UNITED STATES OF AMERICA
NUCLEAR REGULATORY COMMISSION

TEXAS UTILITIES GENERATING
COMPANY, et al.

(Comanche Peak Steam Electric Station
Station, Units 1 and 2)

CASE'S PARTIAL ANSWER TO APPLICANTS' STATEMENT OF MATERIAL FACTS AS
TO WHICH THERE IS NO GENUINE ISSUE REGARDING APPLICANTS' USE OF
GENERIC STIFFNESSES INSTEAD OF ACTUAL STIFFNESSES IN PIPING ANALYSIS

FIG 1

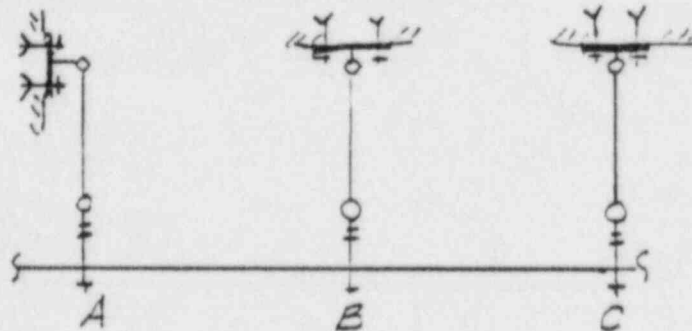
A simple example can demonstrate the consequences of not considering a gap in the base plate. Referring to Figure 1 following, there are three identical (except for their base plate connection) supports labeled A, B, and C, which are supporting a pipe. Because A, B, and C are identical (except for their base plate connection), they

all have an equal amount of stiffness and supports A and C will receive an equal amount of load. For purposes of this example, it will be assumed that the support stiffness is equal to 1,000 lbs. per 1/16" deflection. But support A has a base plate that will transfer the load to the bolts in shear. However, since the base plate was designed as a bearing type connection and slippage is possible, support A will deflect and have a different amount of stiffness now. This stiffness now will be 1,000 lbs. per 3/16" deflection assuming a 1/8" oversize hole in the base plate. The result is the stiffness of support A is 3 times less than that of supports B and C, and with the Applicants' present procedure, this is not accounted for. The results of using incorrect stiffnesses is the subject of Applicants' Motion, but Applicants not using consistent design practices; i.e., bearing type connections for the design of the base plate, friction type connection for the stiffness or deflection calculation.

SUPPORT NO. CC-2-011-703-A632

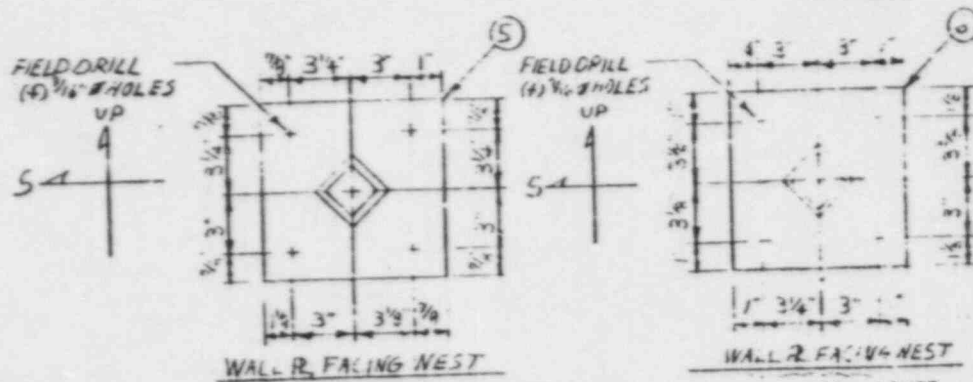
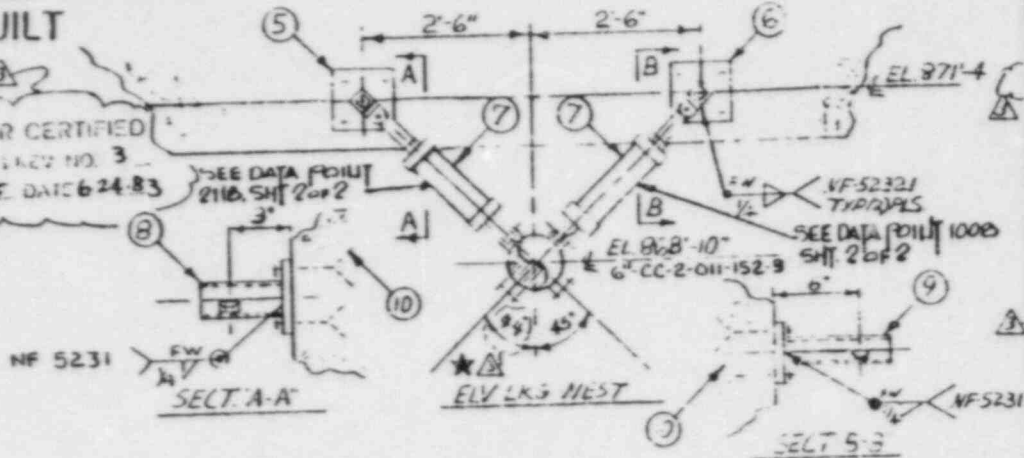
- Attachment A Drawings and calculations for support CC-2-011-703-A63R -- see answer 4, page 12
- Attachment B Drawings and calculations for support CC-2-11-704-A63R -- see answer 4, page 12
- Attachment C Drawings and calculations for support CC-2-011-706-A63R -- see answer 4, page 12
- Attachment D 8/17/84 letter from B. J. Youngblood, Chief, Licensing Branch No. 1, Division of Licensing, NRC, Washington, to M. D. spence, President, TUGCO -- see answer 5, page 16
